**Roof Types Per RFI 4889 & 4889.1**

DRAWING TITLE  
BLDG 8 ROOF PLAN

PROJECT TITLE  
SLVHCS REPLACEMENT MEDICAL CENTER PROJECT

DRAWING NUMBER  
**8AS106**

1 1-8 B8 Level ROOF  
1/8" = 1'-0"

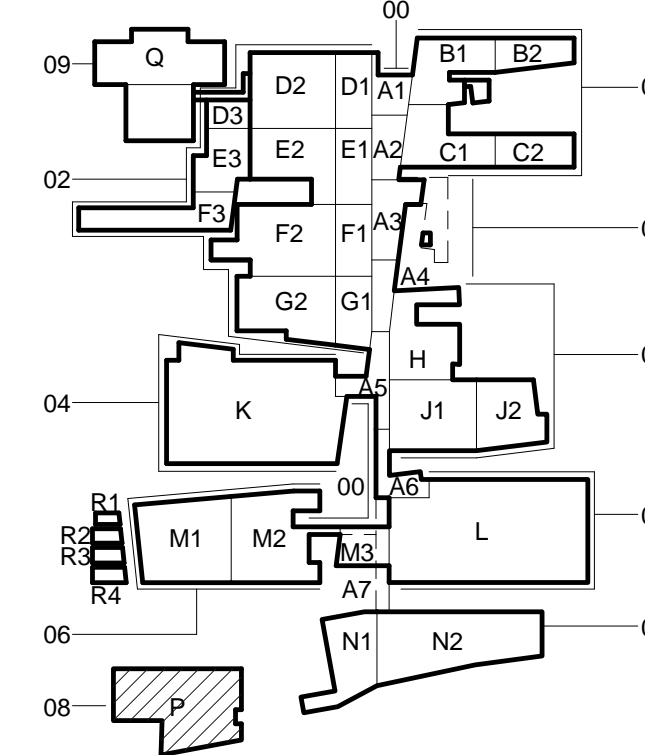
**R-MB2:** Typical roof to be used

**R-MB3:** Roof to be used at food service exhaust hood. Provide a 30ft. square centered on the exhaust outlet.

**R-MB4:** To be used on remaining existing roof construction of Dixie.
